City of Nedlands

Arts Committee Meeting

22 July 2019

7.1 Location of Artworks in Annie Dorrington Park

Artist's Proposed site for both Artworks

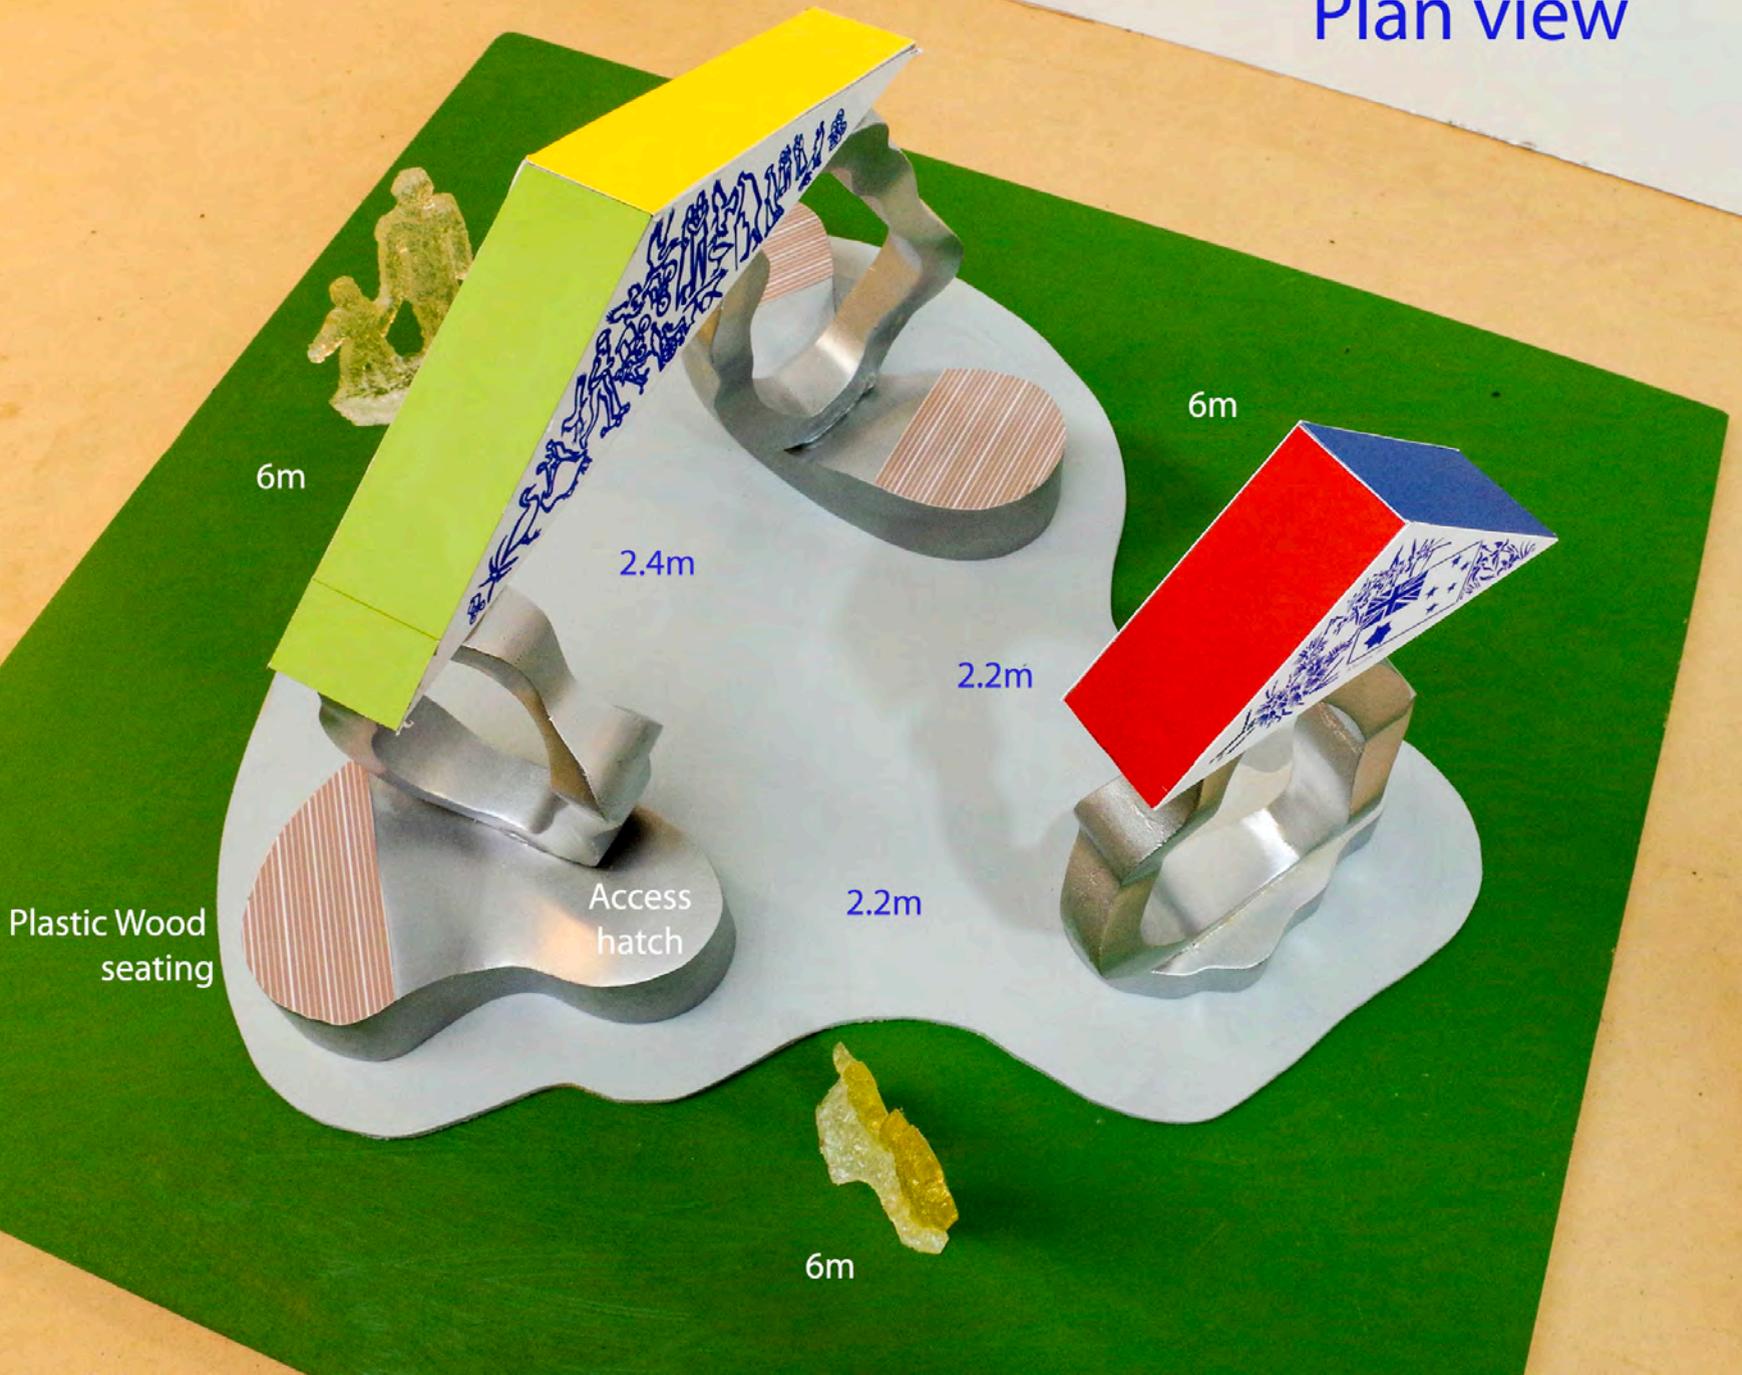
The model presented at the June meeting has three large vertical forms, each sitting on a horizontal seat. Two of the large vertical forms are connected to each other by a large 'roof'. The third vertical form also has a (smaller) 'roof', which is not connected to the other two vertical forms. A significant new element of the proposal was that all three vertical structures were proposed to be located on a large decorative cement slab or platform. This platform is in addition to the seating that is part of each sculpture and its footings. A plan of this proposal is provided at Attachment 1 – Option 1 for Location of Artworks in Annie Dorrington Park.

Following the Arts Committee meeting on 17 June 2019, some concerns have been raised about the proposed location of the works, particularly the impact of the large decorative cement slab on which the works were proposed to be located. Additionally, information on the cost of installation of the works is now available and is presented to the Arts Committee in this report.

- Dominance of the artwork – whether placing the sculptures on a large platform will result in them dominating, rather than fitting into, the park.
- The impact of introducing a large expanse of concrete into the small park.
- "Heat island" effect created by the large expanse of concrete.
- How the larger concrete platform will work with the contours of the park.

The main concern about the proposed location and configuration of the artwork is the effect of the proposed decorative platform. There is concern that putting the sculptures on a platform may destroy the balance between the artwork and other uses of the park – that it would elevate the artwork to a dominant position, rather than it being integrated into the park. There is concern that the park could become merely a setting for the artwork, rather than a community space with many uses, including experiencing the artwork. A desirable balance would be that park users can enjoy and appreciate the artworks without any of their other ways of using the park being hampered.

The Mt Claremont area has a relatively low amount of public open space, which will therefore make this park particularly important for a variety of uses. Because the park is small, maximising planting, including lawn area, is particularly important for a range of informal activities. The proposed large slab or decorative platform will reduce the amount of lawn area.

Increasing the amount of concrete in a relatively small park will also contribute to “heat island” effect, with the park becoming hotter because of radiant heat from concrete and metal. For this reason, Committee members may wish to consider maximising the amount of planted area, particularly lawn area, in proportion to concrete, metal and other heat-radiating materials.

There is also concern about the impact of the proposed decorative slab on the contours of the park. The slab or platform itself would be level, while the ground area on which the platform sits, slopes. Therefore, there is concern that this will result in a “lip” at one end of the concrete platform, with a drop to the lawn area. The previous proposal, to locate the sculptures separately in the park and not joined by a decorative slab, avoids this problem as the lawn between the separate sculptures would simply provide a gradual slope.

- 1. locates artworks by Tony Pankiw in Annie Dorrington Park as at Attachment 2 – Option 2, Separating the Two Sculptures in the Park;**
- 2. commits expenditure of \$9,435 to the installation of artworks referred to above;**
- 3. requests Technical Services to provide detailed drawings of the installation including accurate elevation, plan and footing detail drawings including mowing and hard stand underneath seating; and**
- 4. requests the CEO appoint a project coordinator for the installation of this artwork and other works at the park including the St John’s Wood Boulevard Public Open Space Playground installation.**

Therefore, it is recommended that the artworks be installed in Annie Dorrington Park according to Option 2, Separating the Two Sculptures, as at Attachment 2 – Option 2: Separating the Two Sculptures, at a cost of \$9,435.
